**Marion County
Board of County Commissioners**

**PLANNING & ZONING SECTION
STAFF REPORT**

Public Hearings:	P&Z Date: 07/27/2026	BCC Date: 08/18/2026
Case Number:	260804SU	
EPL Plan Number:	PL SUP-000812-2026	
Type of Case – Special Use Permit:	Warehouse with accessory office space and parking in a B-4 zone	
Owner	2745 PDH Extension LLC	
Applicant	Kevin Steiner / Perfect Deed Homes LLC	
Street Address	No address assigned; north side of Chestnut Road, ±520' west of SE 58 th Avenue (Baseline Road)	
Parcel Identification Account Number (PID)	9024-0565-06	
Property Size	±1.23 acres	
Future Land Use	Commercial (COM)	
Zoning Classification	Regional Business (B-4)	
Overlay Zone / Scenic Area	Primary Springs Protection Zone, Urban Growth Boundary	
Staff Recommendation	Approval with Conditions	
P&ZC Recommendation	On Consent: Approval with Conditions (6-0)	
Project Planner	Xinyi Cindy Chen/Christopher D. Rison	
Related Case(s)	None	
Code Cases	None

Figure 5
Concept Plan

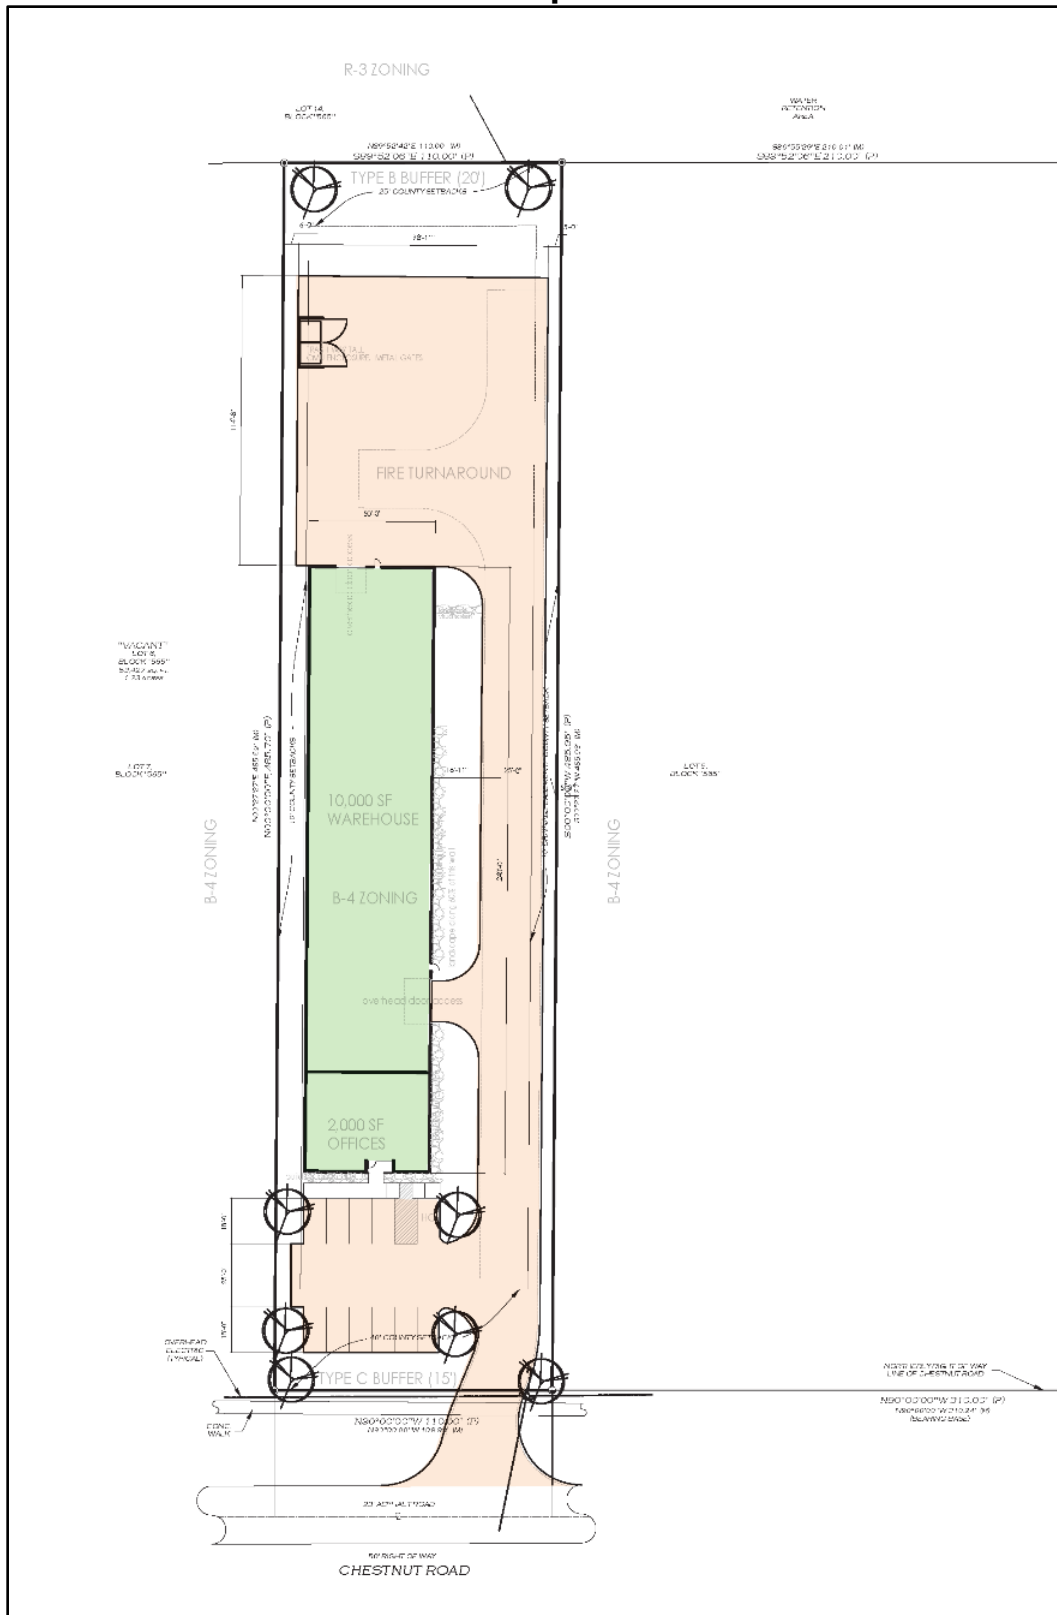
Analysis: A single driveway entrance from Chestnut Road will provide ingress and egress to the site, with the access drive extending along the east (right) property line to the rear of the building, widening into a service, loading, and turnaround area expected to be capable of accommodating fire apparatus. The site driveway and overall access will be required to comply with the provisions of the LDC and the conditions of this SUP. Per Development Review Committee (DRC) staff review comments provided by the Office of the County Engineer, a cross-access easement along Chestnut Road is recommended as that roadway is a Major Local Road that serves as a key access route into the Silver Springs Shores subdivision areas to the west, as well as the Emerald Shores Elementary School. A condition has been added accordingly. Staff conclude that the application **is consistent** with provisions for ingress and egress as recommended.

Analysis: The concept plan (see Attachment B) depicts off-street parking including a handicapped accessible space on a paved surface in front of the building, screened from Chestnut Road by a 15-foot Type C landscape buffer. Loading and service access occurs at the side and rear of the building via the extended access drive and rear paved area. The concept plan indicates paved areas encroaching into established easements, which must be appropriately corrected as part of the development review process to either remove/adjust the paved areas or achieve suitable easement encroachment authorizations, or vacations of the easements. The amount and form of the site parking will be required to comply with the provisions of the LDC and the conditions of this SUP. The proposed warehouse with office use is not anticipated to generate significant noise, glare, or odor impacts to surrounding properties *as an enclosed facility*. Staff note the side and rear loading access doors are a possible concern if on-site activities take place with the doors open or if there is site activity in the early morning or late evening

Analysis: The Findings of Facts (FOF, see Attachment B) state that solid waste collection will be provided by WastePro. A dumpster will be located at the rear of the site, enclosed within a 6-foot concrete masonry unit (CMU) wall with metal opaque gates; however, the concept plan shows the facility encroaching into the required 10-foot side setback (as well as into the site's 7.5-foot drainage and utility easement) which must be appropriately corrected as part of the development review process to adjust the location more internally. Generally, once adjusted, the rear placement and screening treatment will be consistent with LDC requirements and adequately screen the refuse area from public view and adjacent properties. The application is **consistent** with this provision.

Analysis: The Findings of Facts letter states that landscaping will comply with the Marion County Landscape Ordinance. Landscape coverage is provided along approximately 60% of the building's front and east exterior walls. The concept plan depicts a 15-foot Type "C" Buffer along Chestnut Road. The concept plan references a Type "B" Buffer along the north boundary as the adjoining property is zoned R-3, with no buffers indicated along the east and west sides where the

adjoining properties are commercially zoned. However, the north and east property boundaries adjoin the public purpose FDOT SE 58th Avenue WRA where only a Type “C” Buffer is required. Across the FDOT WRA to the east is an older developed commercial site and other vacant commercial parcels forming the northwest corner of the SE 58th Avenue & Chestnut Road intersection. To the north there are existing single-family homes located ±134-feet across the open FDOT WRA. *While the concept plan and FOF do not indicate any outdoor storage is proposed*, the site’s rear loading and access areas will be visible to the north across the open FDOT WRA, and staff recommends adding a minimum 6-foot-high solid opaque privacy fence (not consisting of chain-link with fabric, mesh, or slats, etc.) to be provided and maintained along the interior side of the north boundary’s Type “C” Buffer to further deter any light, sound, dust, or debris from escaping the site in to or across the FDOT WRA. Staff note compliance with LDC landscape requirements, including buffer width, plant species, and spacing, and the conditions of this SUP must be demonstrated and confirmed through site plan review. As referenced and recommended, the buffers to be provided will ensure the application **is consistent** with the provision of screening and buffering.

Analysis: The building will comply with all required B-4 setbacks (40-foot front, 25-foot rear, 10-foot sides) and height limits as depicted on the concept plan. Pursuant to the Silver Springs Shore Unit 24 Subdivision Plat, the site is subject to a standard 7.5-foot-wide drainage and utilities easement along its front, rear, and side lot lines; further, the east boundary is subject to a lot-specific 10-foot-wide drainage easement (overlapping the noted 7.5-foot easement) that is referenced on the concept plan. As noted previously, the paved areas encroaching into established easements, which must be appropriately corrected as part of the development review process to either remove/adjust the paved areas or achieve suitable easement encroachment authorizations, or vacations of the easements. The dumpster/refuse location will also require final adjustment and correction to ensure there is no encroachment into required setbacks or any easements. The site's Major Site Plan will be required to resolve the final design adjustments through the development review process and demonstrate compliance with the LDC and the conditions of this SUP. As compliance with the LDC development review process and the recommended SUP conditions will necessary as noted, it is concluded that the application **is consistent** with the required yards and other green space requirements of this section.

- **Cross access for and parallel to Chestnut Road shall be required with the site's development, with the final design subject to the County Engineer's review and approval.**

- **A Type “C” Buffer (minimum 15 feet) shall be provided and maintained along the site’s the Chestnut Road frontage, and no waivers to that buffer may be permitted, except the buffer shade trees may be provided as accent/ornamental trees consistent with the LDC due to the presence of overhead powerlines along the Chestnut Road frontage.**

- **A Type “C” Buffer (minimum 15 feet) shall be provided and maintained along the site’s north and east property boundaries. Further, along the north property boundary a minimum 6-foot-high solid opaque privacy fence (not chain-link or similar open pattern fencing with fabric, mesh, or slats, etc.) to be provided and maintained along the interior side of the north boundary’s Type “C” Buffer to further deter any light, sound, dust, or debris from escaping the site in to or across the FDOT WRA.**

- **No outdoor storage shall be permitted, except for the site’s enclosed dumpster/refuse area being provided consistently with the concept plan and Findings of Fact.**

2. The site shall be developed in conformance with the proposed concept plan and the SUP conditions provided, along with conforming to the Marion County Land Development Code (LDC) as applicable at the time of site plan application.
